Addendum #4

**T25-53 - Changeroom Alterations at Pine Ridge
S.S.**

Project Name	Pine Ridge S.S. Changeroom Renovation	Project Number	25-101B
Issue Date	December 4, 2025	No Pages Inc. Cover	2

A800

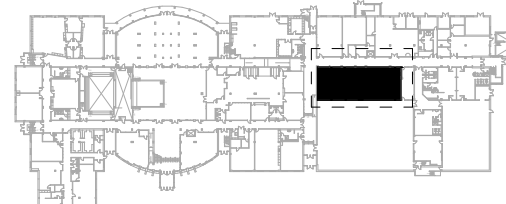
3.3	Replace Sheet A800 Finishes Plan with new, dated December 4, 2025.
